# *Farnborough Airport*

## Airspace Consultation Feedback Report **Part B** The Proposed Airspace Design

## Feedback Report Part B

Figure 3 Extent of Farnborough departures to 7,000ft compared with original consultation areas

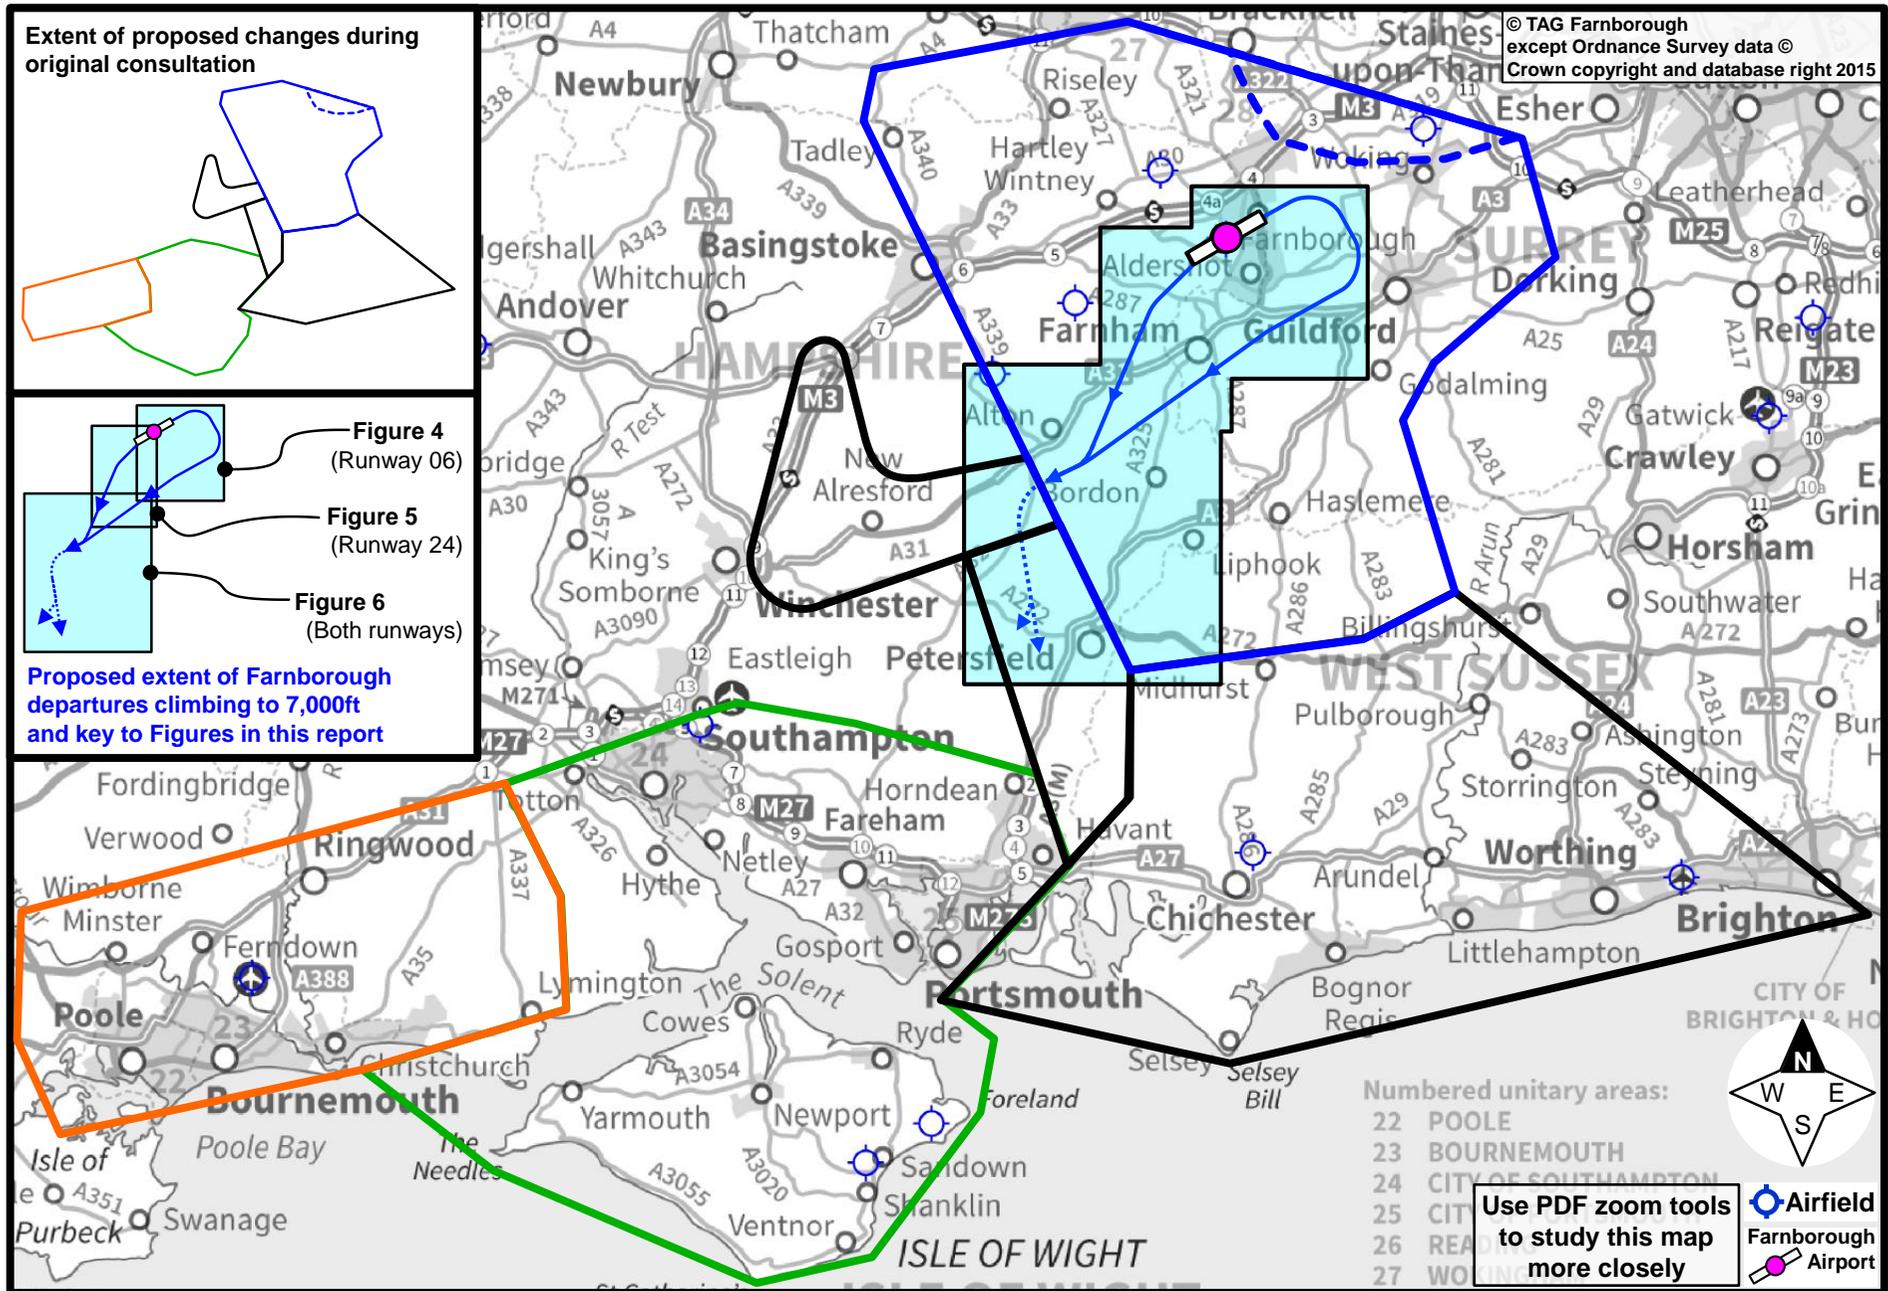
- 4.5. Figure 3 illustrates the extent of the proposed Standard Instrument Departure (SID) routes post-consultation. The originally-consulted-upon swathes have been refined into tight lines.

Figure 4 Proposed Runway 06 departure track up to 5,000ft

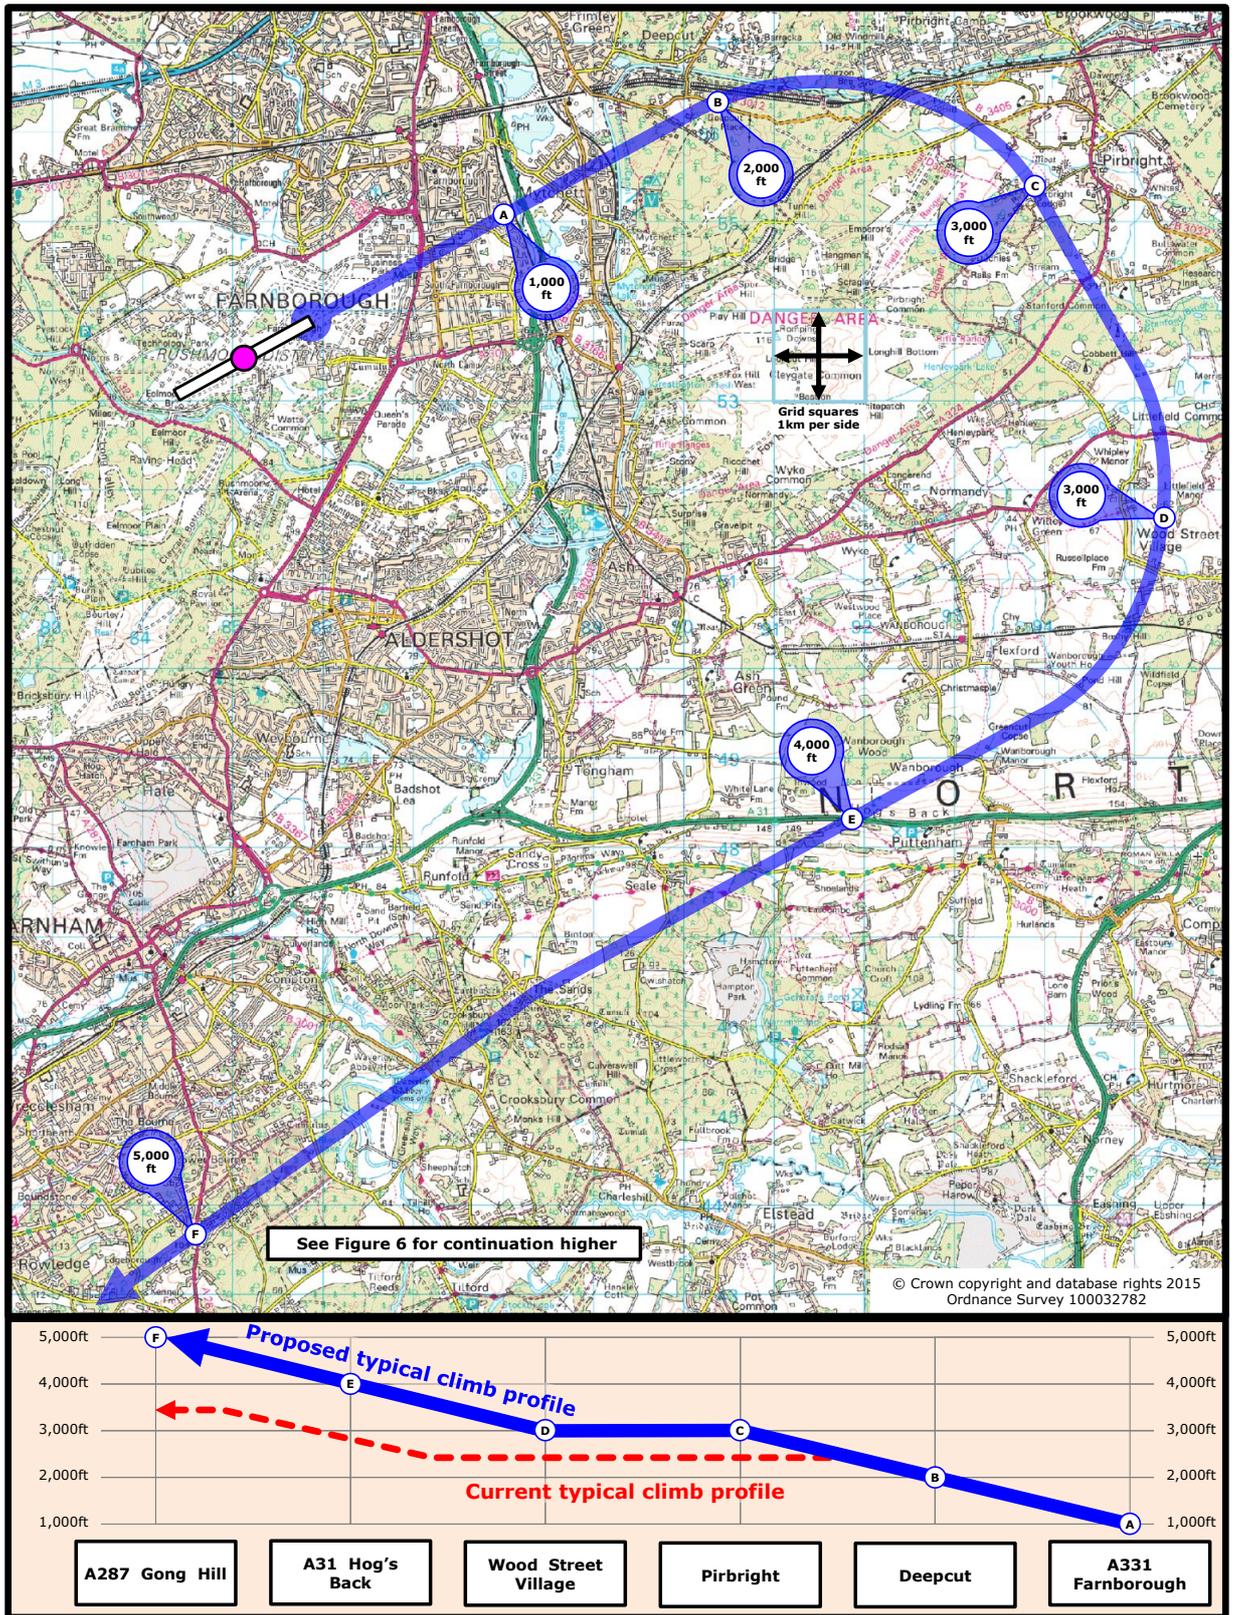
- 4.15. The route for departures from Runway 06 is shown in Figure 4.
- 4.16. It has been designed to avoid direct over-flight of Guildford, Aldershot and Farnham, consistently crossing sparsely populated areas as much as possible, and at higher altitudes than currently achieved.

- 4.17. It takes the following considerations into account:
- a. No change for the first 2,000ft of straight-ahead climb.
  - b. First turn between 2,000ft and 3,000ft starts before Pirbright, to keep the track close to the MoD ranges.  
This is at least 600ft higher than current departures achieve in the same area (red dashed arrow).

- h. National Parks are not over-flown in this portion of the route up to 5,000ft.
- 4.18. See Figure 6 for information about the track as it climbs southwest of Farnham.

Figure 5 Proposed Runway 24 departure track up to 5,000ft

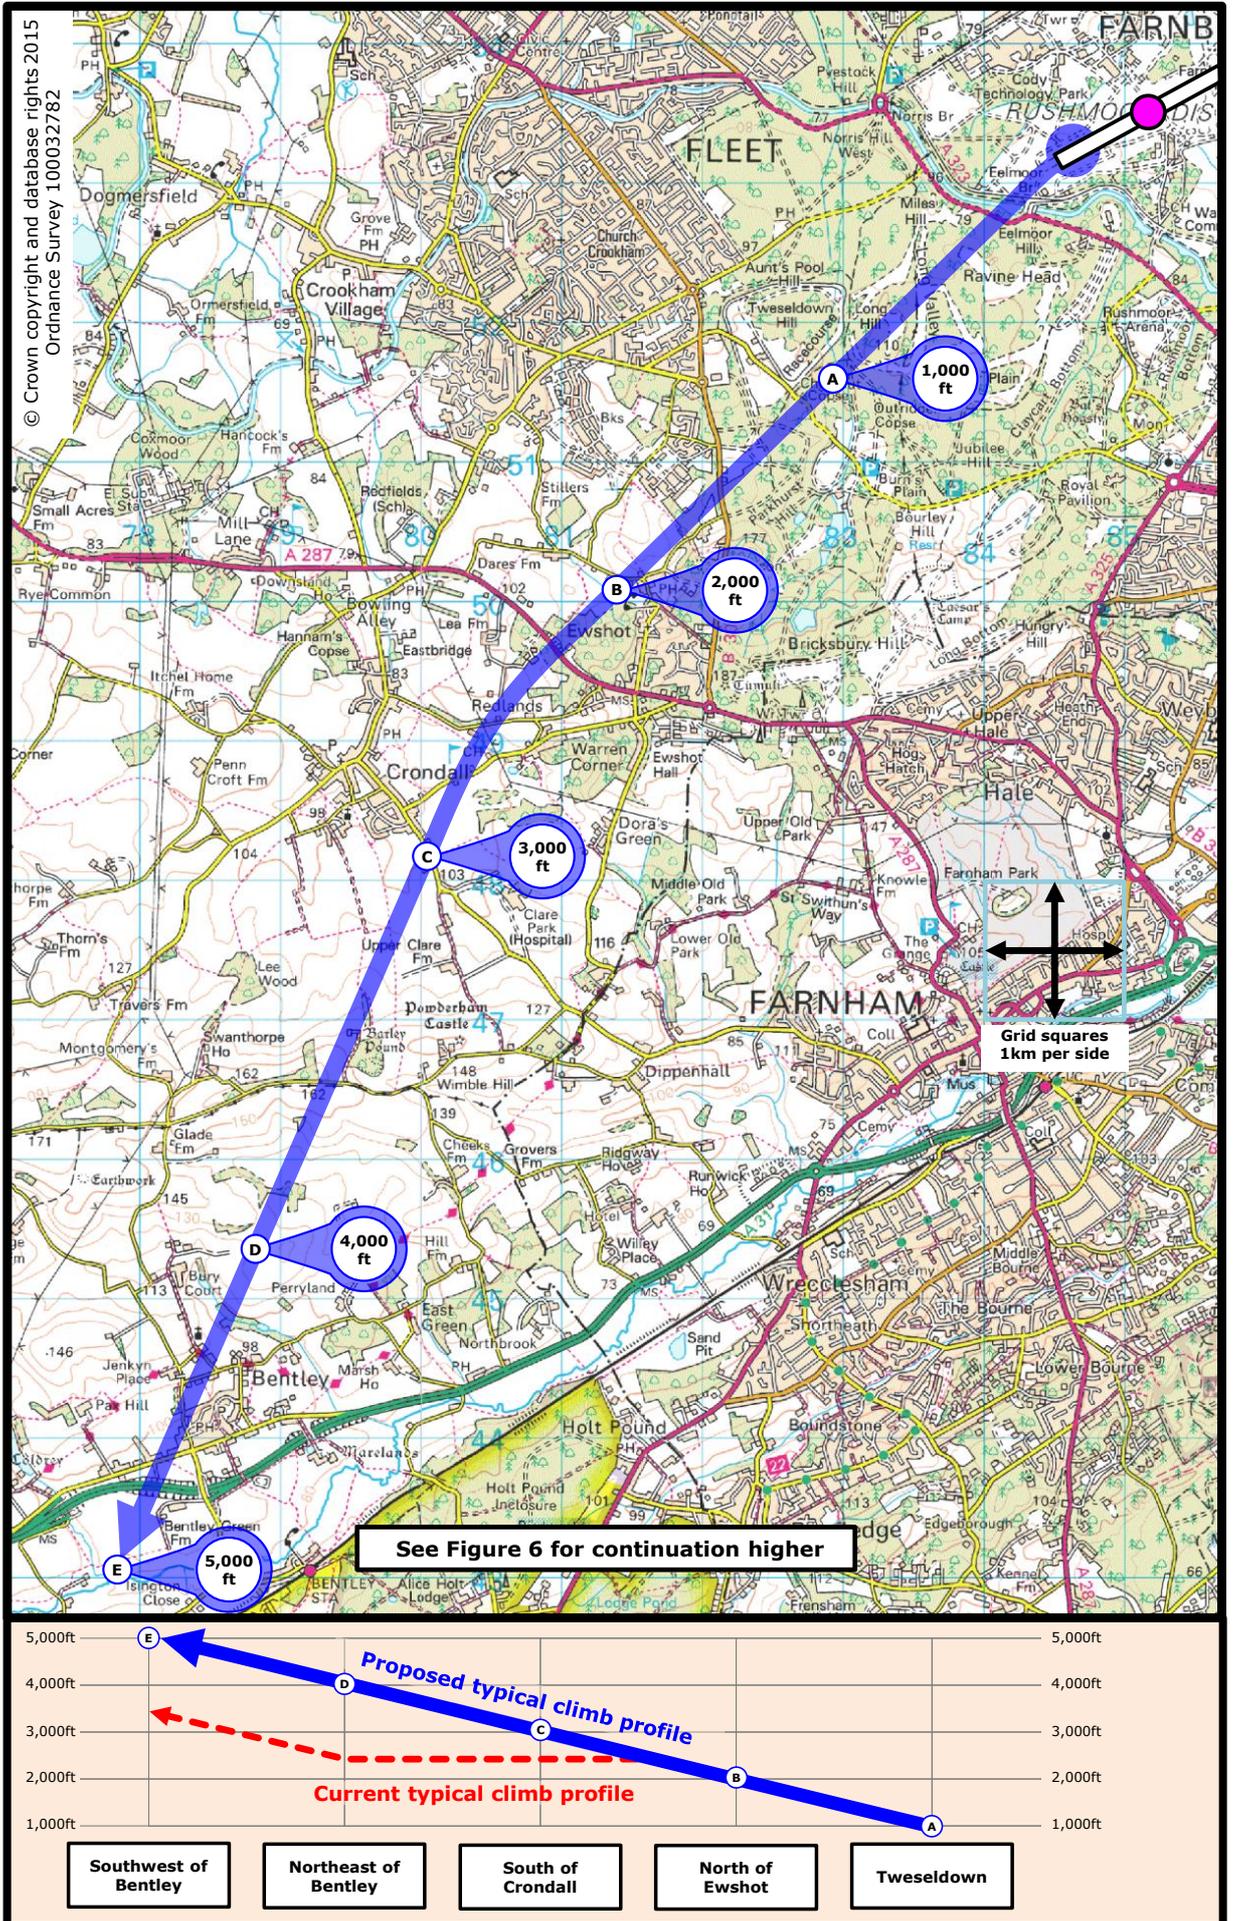
- 4.20. The route for departures from Runway 24 is shown in Figure 5.
- 4.21. It has been designed to avoid direct over-flight of Church Crookham, Fleet, Ewshot, Crondall, Farnham and Alton, consistently crossing sparsely populated areas as much as possible, and at higher altitudes than currently achieved.

- f. Areas of Outstanding Natural Beauty and National Parks are not over-flown in this portion of the route up to 5,000ft.
- 4.23. See Figure 6 for information about the track as it climbs southwest of Bentley.

Figure 6 Departures from both runways from 5,000ft to 7,000ft

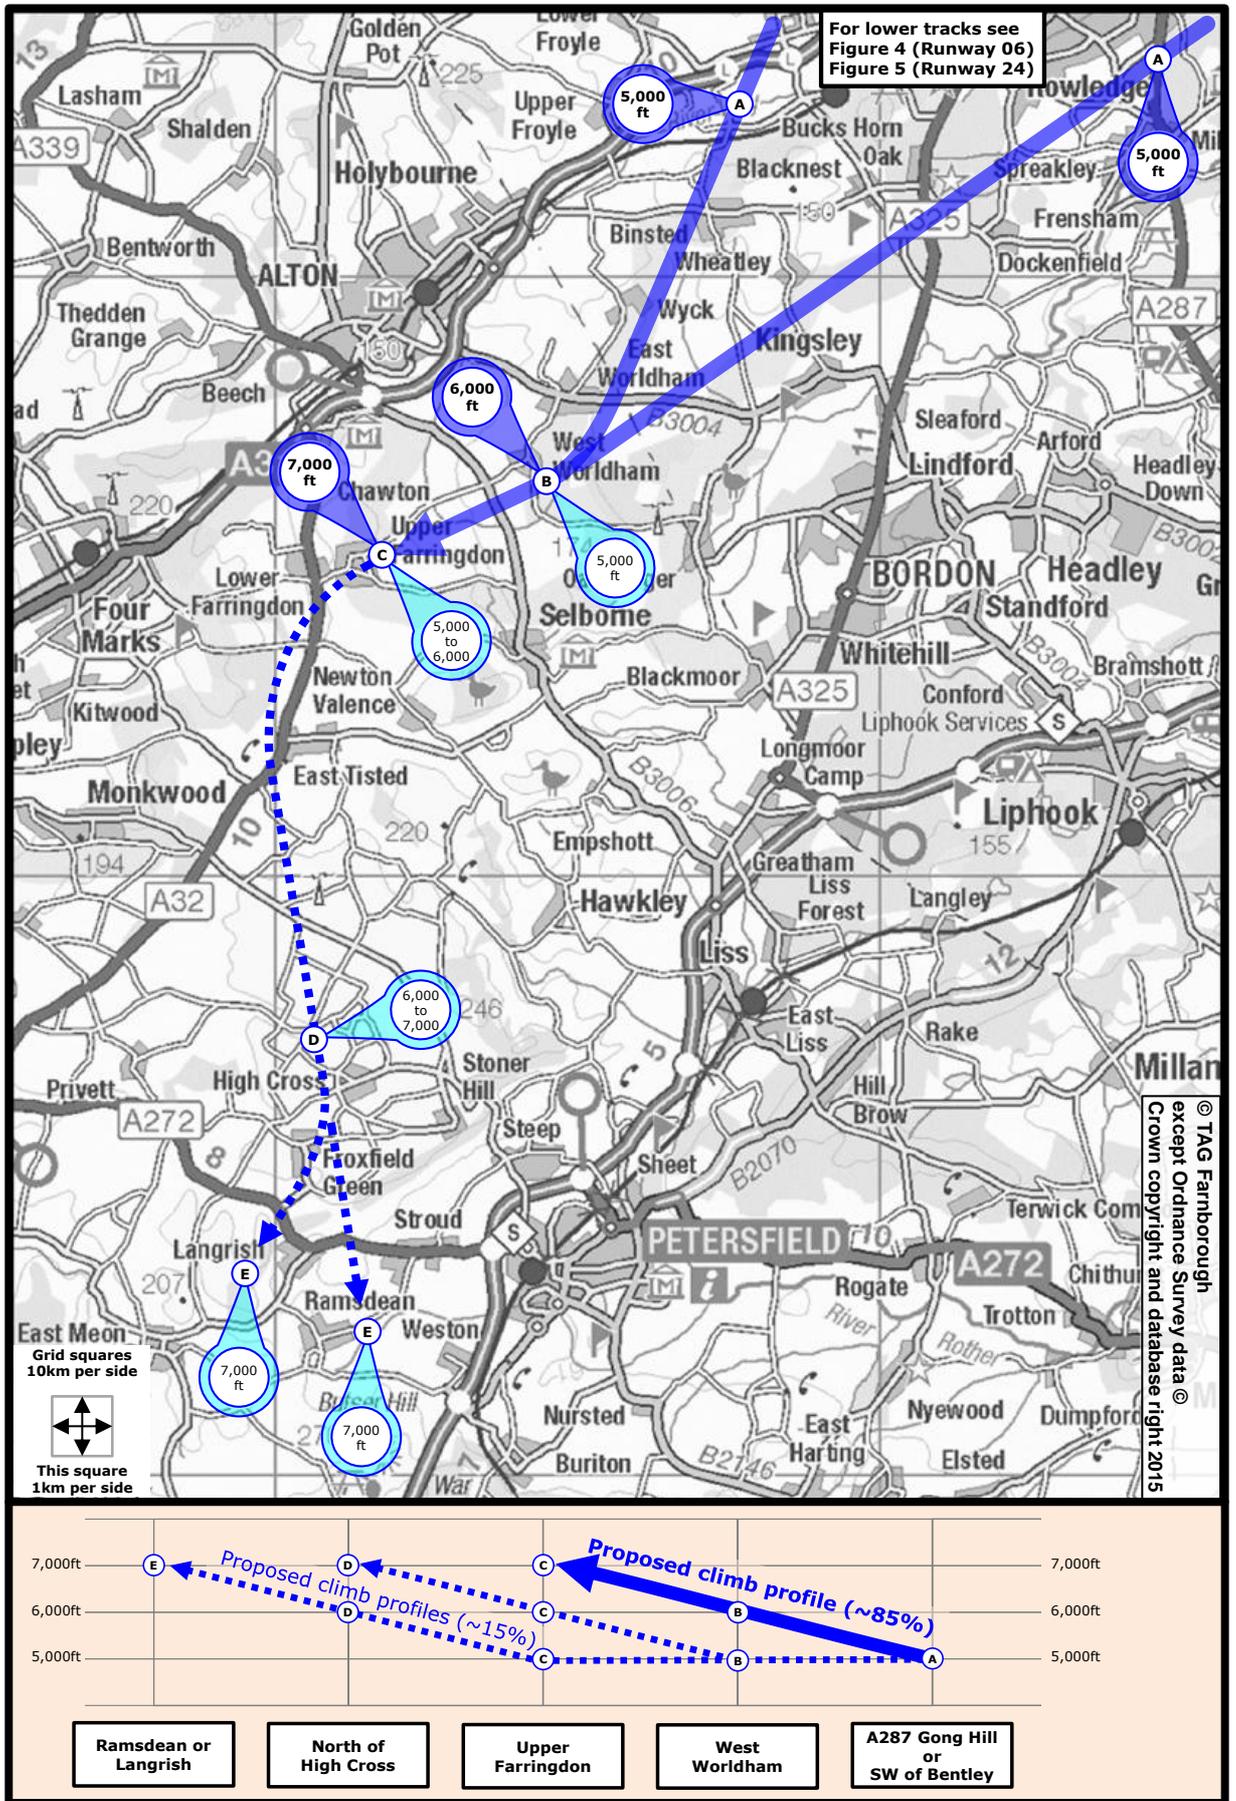
- 4.25. Routes from both runways for departures from 5,000ft to 7,000ft are shown in Figure 6 adjacent.
- 4.26. It has been designed to avoid the major centres of population such as Alton, Bordon, Liphook, Four Marks, Ropley and New Alresford area below 7,000ft, consistently crossing sparsely populated areas as much as possible, and at higher altitudes than currently achieved.
